THM 700-R4"UPDATE HANDBOOK"

INTRODUCTION THM 700-R4 (4L60) UPDATE HANDBOOK

The 1987 through 1993 THM 700-R4 transmissions were produced with many engineering design changes. These changes have affected nearly every part used in the 700-R4. This "Update Handbook" will explain each change, the reason for the change, the parts that are affected by the change and any parts interchangeability concerns created by the change. 1993 was the last year the 700-R4 transmission was produced and this manual will cover all changes up through and including the 1993 changes.

Figure 6

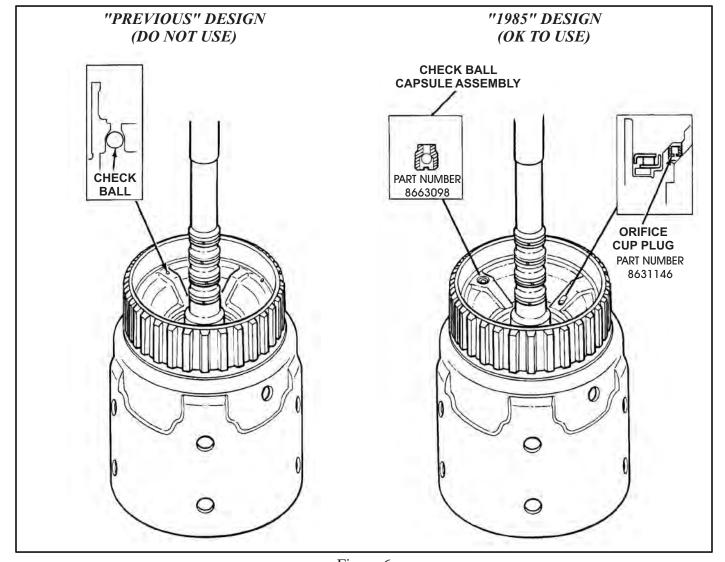
(1) INPUT HOUSING ASSEMBLY - The previous design input housing had a check ball seat drilled into the housing. A check ball was installed into this hole and the opening was then staked to retain the ball, as shown in Figure 6.

The new design 1985 input housing has a check ball retainer assembly which is pressed into the housing, as shown in Figure 6, and an added air bleed orifice cup plug.

The new design input housing with the ball capsule assembly and the air bleed orifice cup plug can be used on all past models.

Do not use either of the previous design input housings.

Figure 8

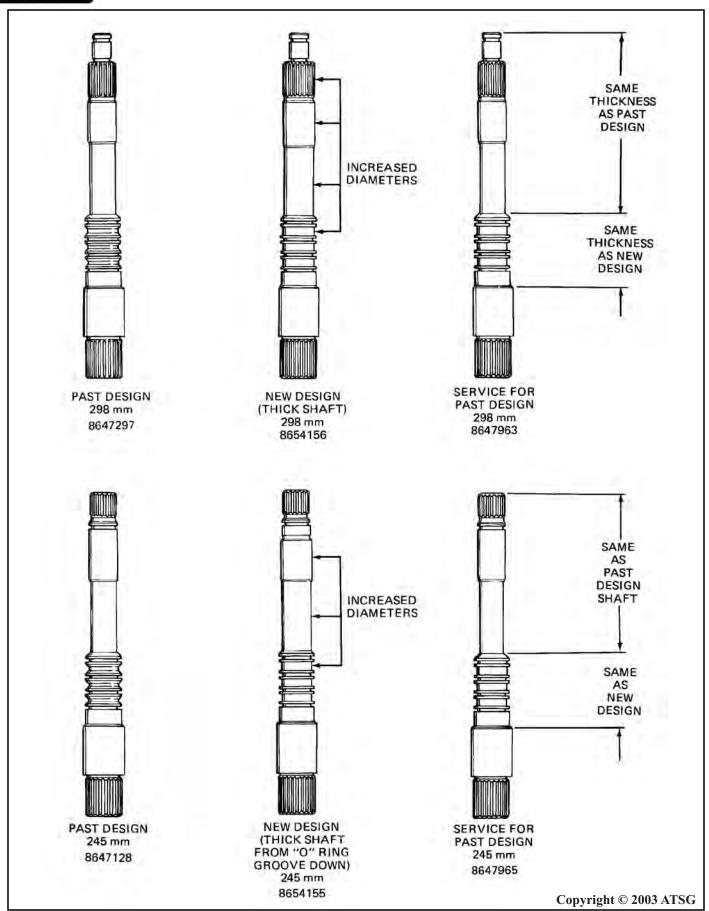
CHANGE: Beginning late in the 1984 model year, Hydra-Matic introduced new design turbine shafts that were larger in diameter, as shown in Figure 8.

- (1) TURBINE SHAFT Increased diameter between the sealing rings, increased diameter of the bushing journal area where it rides in the pump cover, and increased spline diameter for the 298mm converter only, as shown in Figure 8.
- (2) OIL PUMP COVER Increased diameter of the bushing journal area in the stator shaft, to accommodate the increased diameter of the new turbine shaft, as shown in Figure 7.
- (3) TORQUE CONVERTER Increased spline diameter (298mm only) in the converter turbine, to accommodate the new turbine shaft.

In an effort to keep the cost of repairing the transmission to a minimum, another service turbine shaft and input housing was produced to service the 1982 through 1984 models using the original pump cover and torque converter, as shown in Figure 8. The 3rd design turbine shaft is a larger diameter only in the area between the sealing rings where it would crack or break, as shown in Figure 8.

Figure 9

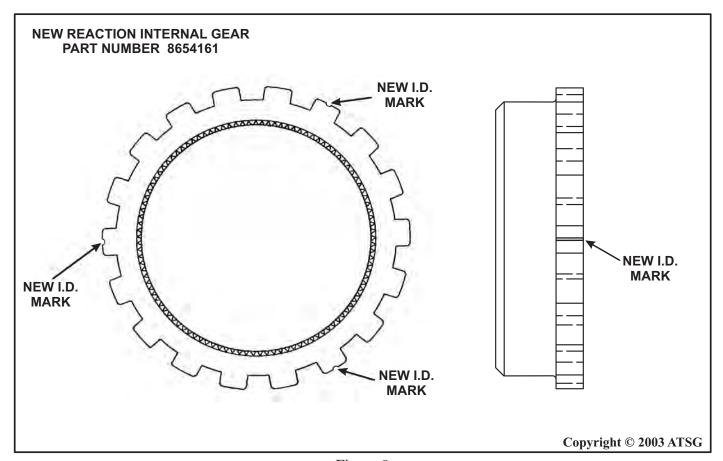
(1) REAR INTERNAL RING GEAR - Manufactured with an improved process to eliminate air bubbles from forming inside and prevent ring gear breakage. Since the improved ring gear is dimensionally the same as the previous, identification marks were added. The new ring gear has broached lines on three parking lugs and are equally spaced around the ring gear, as shown in Figure 9.

The new rear internal ring gear will back service all previous models of the THM 700-R4 transmission and is highly recommended to use only the ring gear with markings as shown in Figure 9.

Figure 10

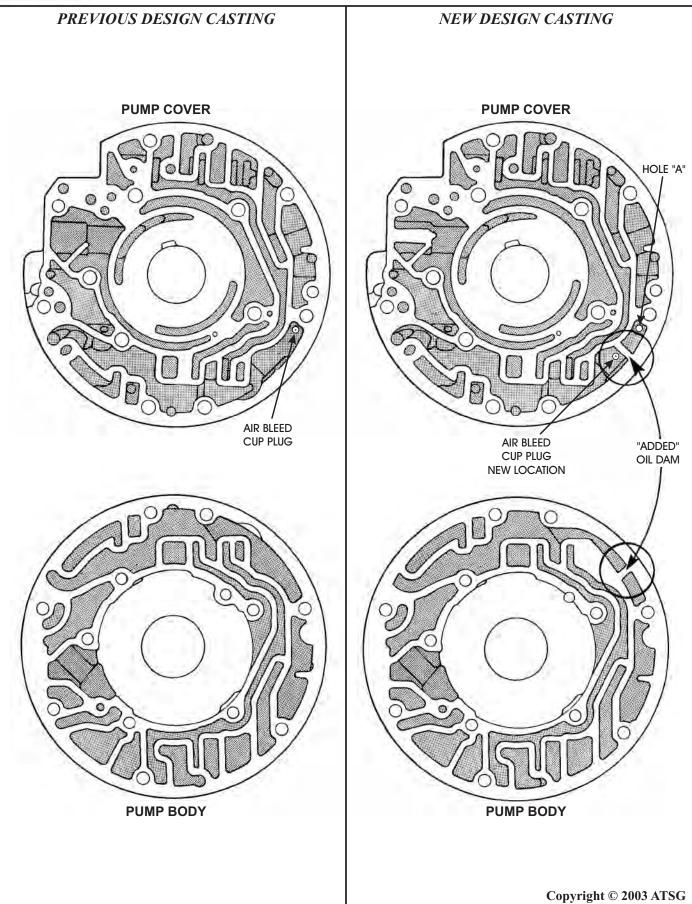
(1) OIL PUMP BODY - Oil dam added to the pump body casting in the line pressure passage, as shown in Figure 10, to prevent the passage from "spreading" and creating fluid leakage. Refer to Figure 10 for the casting changes and Figure 11 for reference casting number locations.

(2) OIL PUMP COVER - Oil dam added to the pump cover casting in the line pressure passage, as shown in Figure 10, to prevent the passage from "spreading" and creating fluid leakage. This change required the air bleed cup plug to be moved inside of the added dam in the line pressure passage, as shown in Figure 10. Unfortunately, they continued to drill the hole in the pump cover in the location of the previous air bleed cup plug. Refer to Figure 10 for the casting changes and Figure 11 for reference casting number locations.

To use the new design oil pump cover (With Oil Dam), you *must* plug the hole that they continued to drill in the location of the previous air bleed cup plug. Plug the hole marked "A" in Figure 10 to prevent a loss of line pressure that goes over the dam in the cover, because of the lack of the matching dam in the previous pump body. However, if you are experiencing oil pump leakage, you should use the "Dam Type" body and cover.

Figure 12

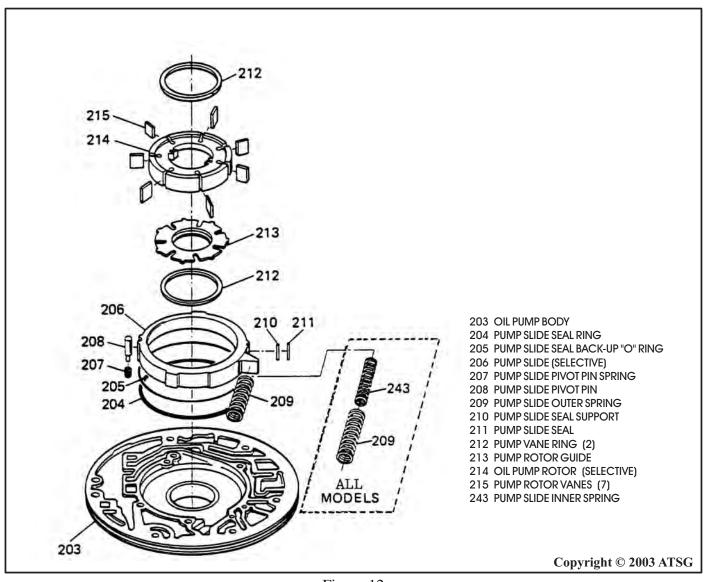
(1) OIL PUMP ASSEMBLY - Now uses an inner slide spring and an outer slide spring, as shown in Figure 12.

Inner Pump Slide Spring	8639562
Outer Pump Slide Spring	8639563

Figure 18

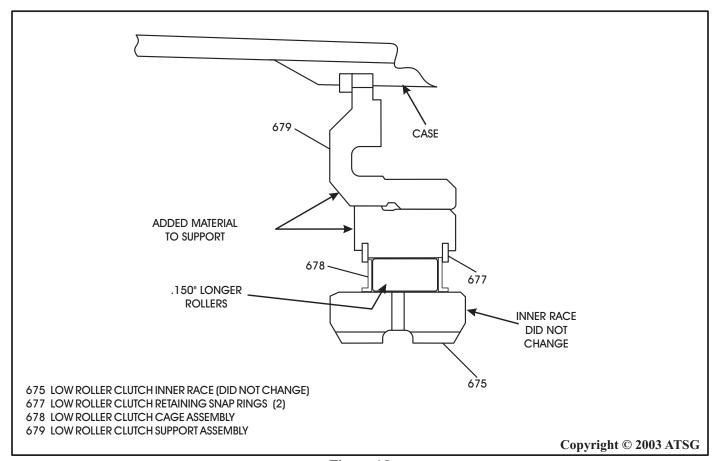
- (1) LOW ROLLER CLUTCH ASSEMBLY The rollers increased in length by .150", which would also change the cage, as shown in Figure 18.
- (2) LOW ROLLER CLUTCH SUPPORT ASSEMBLY Increased length of the support and cam assembly, to accommodate the new design longer low roller clutch, as shown in Figure 18.

General Motors has a service kit available, to update to the new design low roller clutch under part number 8663094.

Figure 21

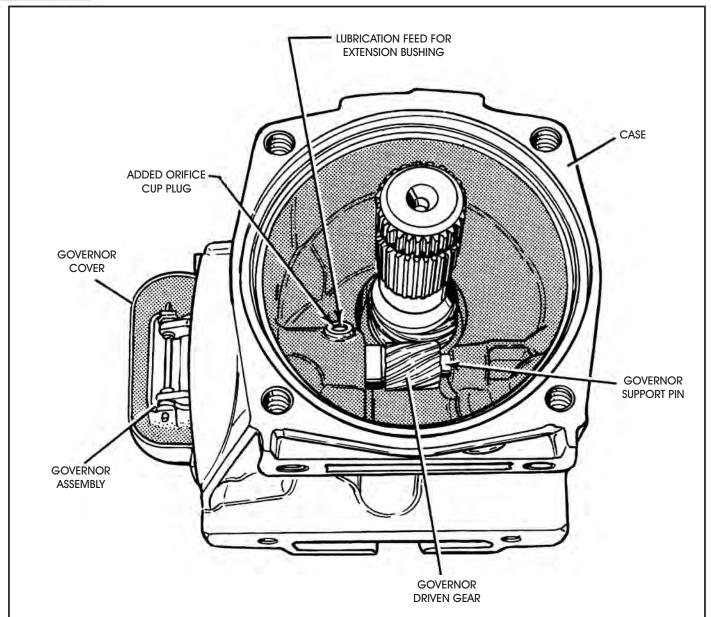
- (1) SPEED SENSOR The added Speed Sensor replaces the speedometer driven gear adaptor and the speedometer drive gear, as shown in Figure 20.
- (2) OUTPUT SHAFT Has an added groove to remove and install the added speed sensor rotor, using a special puller (See Figure 20).
- (3) TRANSMISSION CASE Orifice cup plug added in the governor bore which now provides lubrication to the extension housing bushing, when the speed sensor rotor is used. Refer to Figure 21. This lube was normally provided by the spinning speedometer driven gear teeth tossing oil to the bushing. When the speedo gear is replaced with a speed sensor rotor, the forced lube from the orifice cup plug is required (See Figure 21).

Figure 22

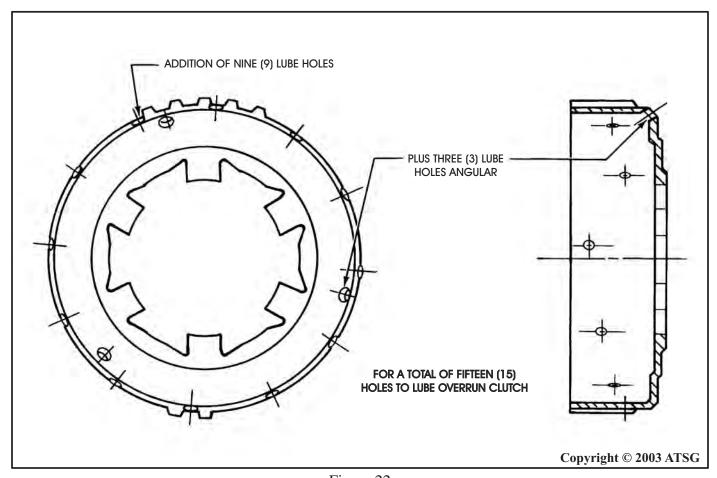
(1) OVERRUN CLUTCH HUB - Now has twelve lube holes drilled in the circumference of the hub instead of the previous three, plus three angular holes for a total of 15 holes, as shown in Figure 22.

The new design Overrun Clutch Hub will come as part of the new design 28 element forward sprag assembly, shown beginning on Page 24, and the new sprag assembly is available under OEM part number 8657928.

Figure 23

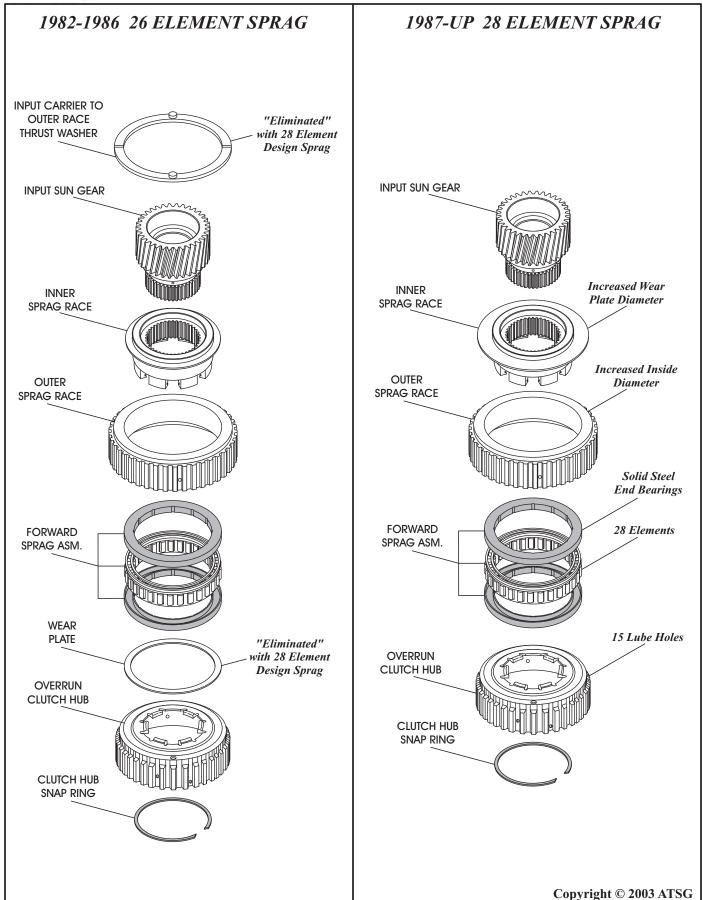
(1) FORWARD SPRAG ASSEMBLY - Increased diameter and addition of two sprag elements for a total of 28, instead of the previous 26 (See Figure 23).

- (2) FORWARD SPRAG OUTER RACE Has larger inside diameter to accommodate the 28 element sprag assembly (See Figure 23).
- (3) FORWARD SPRAG INNER RACE Has larger outside diameter to accommodate the 28 element sprag assembly, and an increase in the diameter of the wear plate that is pressed onto the inner race (See Figure 23).
- (4) FORWARD SPRAG END BEARINGS Now has solid steel end bearings instead of the previous stamped steel end bearings (See Figure 23).
- (5) FORWARD SPRAG WEAR PLATE Eliminated in the 28 element version to make room for the new design solid steel end bearings (See Figure 23).
- **(6)** INPUT CARRIER THRUST WASHER Eliminated in the 28 element version as the increased diameter of the wear plate now supports the outer race (See Figure 23).

The Input Carrier to Outer Sprag Race thrust washer and Wear Plate *are not* required with the new design 28 element Forward Sprag Assembly. Use of the Input Carrier thrust washer with the new design sprag will create a mis-build, as correct front end play cannot be obtained (See Figure 23).

The new design 28 element Forward Sprag Assembly includes the updated Overrun Clutch Hub shown in Figure 22, and is available under OEM part number 8657928.

Figure 24

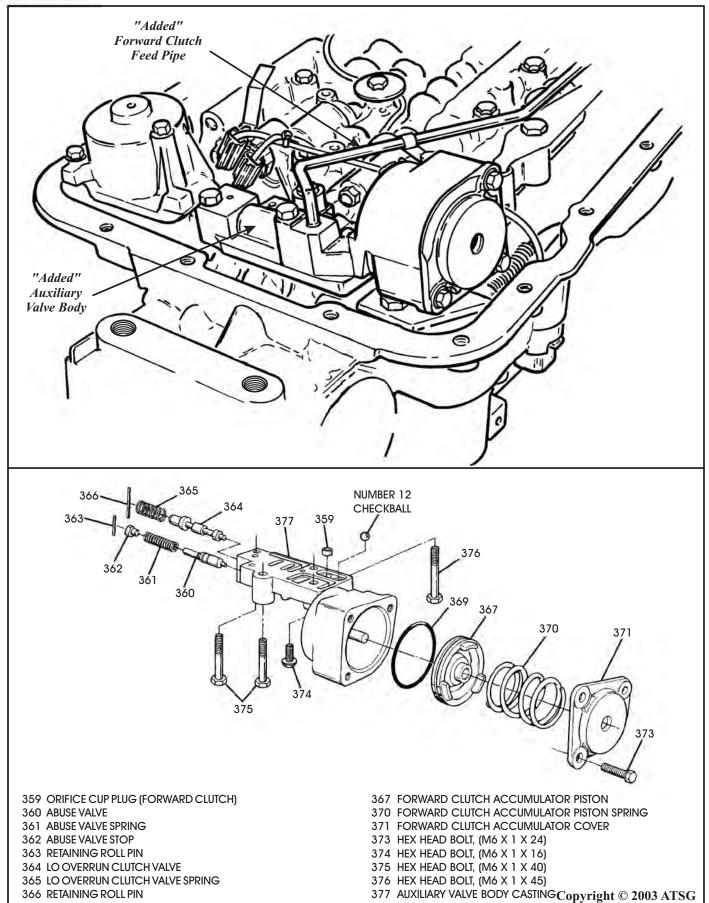
- (1) AUXILIARY VALVE BODY Added as per dates listed above and performs the following:
 - (a) The Low Overrun Valve in the auxiliary valve body provides a smooth 2-1 Manual downshift. It also regulates the pressure applied to the Low/Reverse clutch to a lower pressure (See Figure 24).

- (b) The Abuse Valve in the auxiliary valve body, shown in Figure 24, protects the forward clutch during rock cycles. Rock cycles are the defined as rapidly shifting the transmission back and forth between Reverse and Drive when the vehicle is stuck in mud, sand, snow or ice. At any throttle position higher than idle, the Abuse Valve opens to by-pass the new forward clutch feed orifice cup plug located in the auxiliary valve body. This results in a quicker forward clutch apply time. A quicker apply produces less heat and increases clutch durability.

- (c) A Forward Clutch Accumulator Piston and Spring are incorporated in the new auxiliary valve body, as shown in Figure 24, and provides smoother garage shifts to Drive.

- (5) VALVE BODY SPACER PLATE GASKETS Added holes in both the valve body gasket and the case gasket, to accommodate the added auxiliary valve body.
- **(6)** FORWARD CLUTCH FEED PIPE Added to feed forward clutch feed oil to the oil pump assembly, as shown in Figure 24, to feed the forward clutch pack.

Figure 37

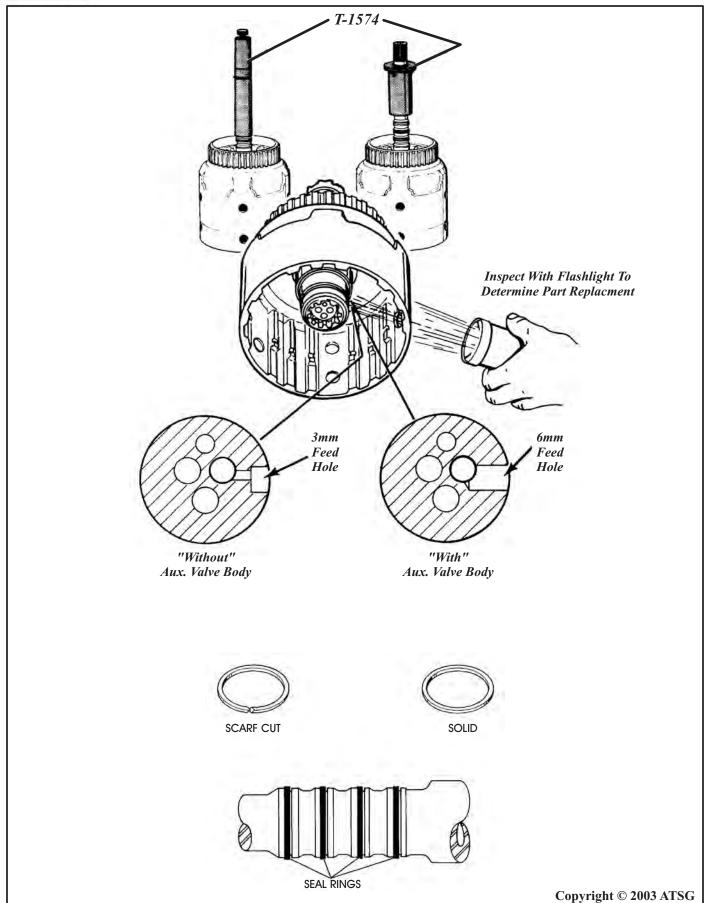
- **(b)** The turbine shaft seals are now solid Teflon, instead of the previous scarf-cut seals. The solid turbine shaft seals require an installation and resizing tool, as shown in Figure 37, and is available under part number T-1574.

- (6) "Always" check the turbine shaft in the input housing assembly using a flashlight, as shown in Figure 37, for an orifice in the forward clutch feed passage.

- (a) Using a 1987 or later input housing *without* this orifice in 1982-1986 models, will result in a very harsh garage shift into drive (See Figure 37)

Figure 38

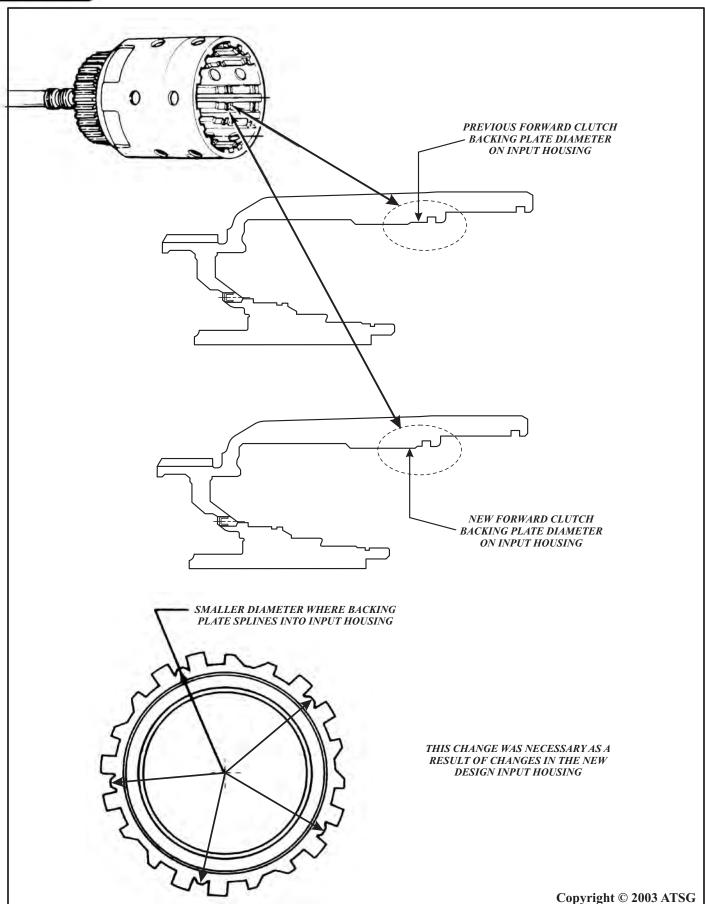
- (c) The Input Housing has a smaller diameter where the backing plate splines into the input housing, and is illustrated in Figure 38. The new design forward backing plate also has a smaller pilot diameter to accommodate the changes in the input housing, as shown in Figure 38.

Figure 39

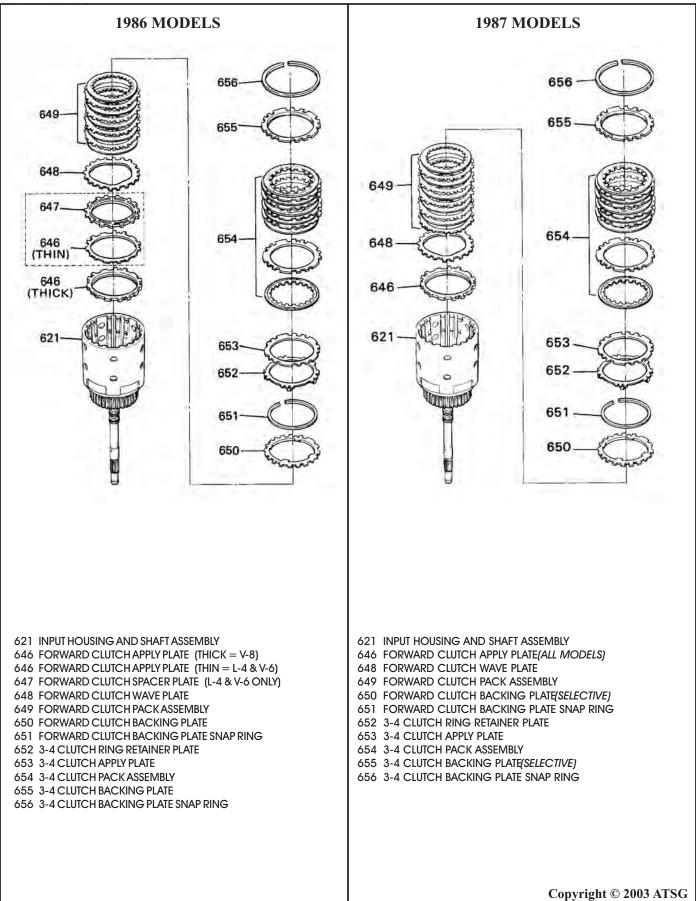
- (d) All models are now built with a forward clutch pack that has five lined plates, as shown in Figure 39. The new design lined and steel plates have a revised thickness, and the forward clutch backing plate is now selective, as shown in Figure 40. We have also listed the OEM Part Numbers for the selective Forward Clutch Backing Plates in Figure 40.

- (7) The forward clutch friction and steel plates are a different thickness in all 1987 and later models, and the forward clutch backing plate is now selective, as shown in Figure 39 and 40. When building an 82-86 unit, do not mix 87 style clutch plates with the 82-86 clutch plates without checking the forward clutch clearance (See Figure 40).

Figure 41

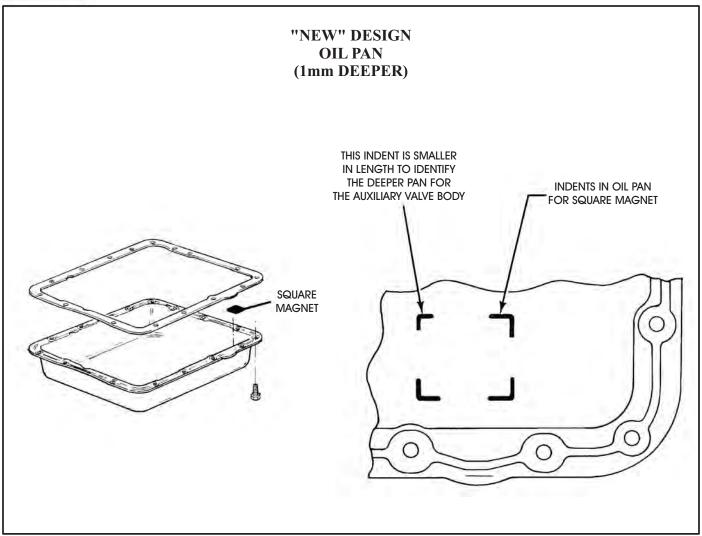
- (10) BOTTOM OIL PAN The bottom oil pan is now 1mm (.040") deeper, to allow clearance for the added auxiliary valve body, and the magnet is now square. For identification of the deeper oil pan, one indentation where the new square magnet goes has shorter legs, as shown in Figure 41.

- (8) The deeper bottom oil pan can be used on any 1982-1986 model THM 700-R4 transmission. The previous model oil pan *cannot* be used on any model that uses the auxiliary valve body, due to insufficient clearance (See Figure 41).

Figure 42

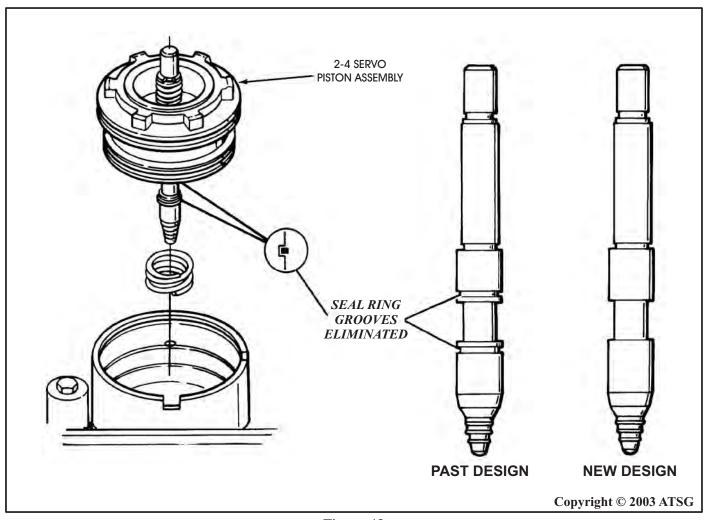
(1) 2-4 SERVO PIN - Seal grooves eliminated in the servo apply pin, as shown in Figure 42. Testing has shown that any potential leakage in this area with the new servo pin will not affect transmission performance or durability.

The new servo apply pin can be used on all previous model 1982-1986 model 700-R4 units. If a previous design servo apply pin is used on any model, the seal rings *must* be installed.

Figure 43

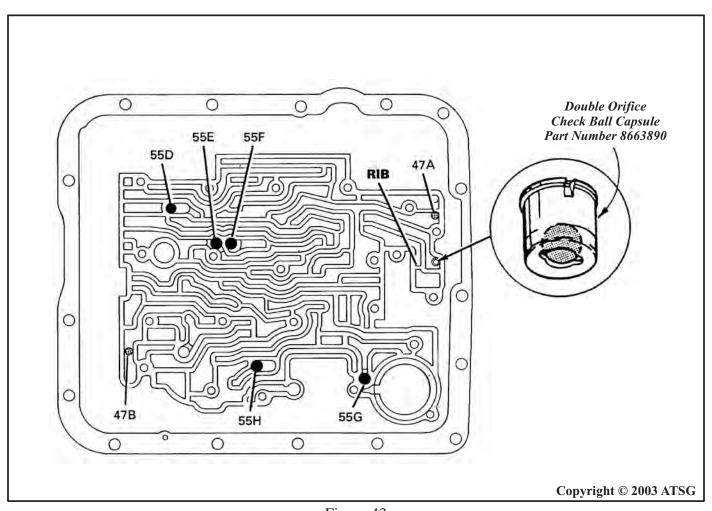
(1) ORIFICED CHECKBALL CAPSULE - Added to the low/reverse passage at the rear of the case in the location shown in Figure 43, which allows for both a controlled apply and a rapid release of the Low/Reverse clutch.

- (6) ORIFICED CHECKBALL CAPSULE Added to the low/reverse passage at the rear of the case in the location shown in Figure 43, which allows for both a controlled apply and a rapid release of the Low/Reverse clutch.

This Double Orifice Checkball Capsule is part of a reverse apply package involving other components and design changes for 1987 through 1993 models with Auxiliary Valve Body. This Double Orificed Checkball Capsule *cannot* be used in previous models.
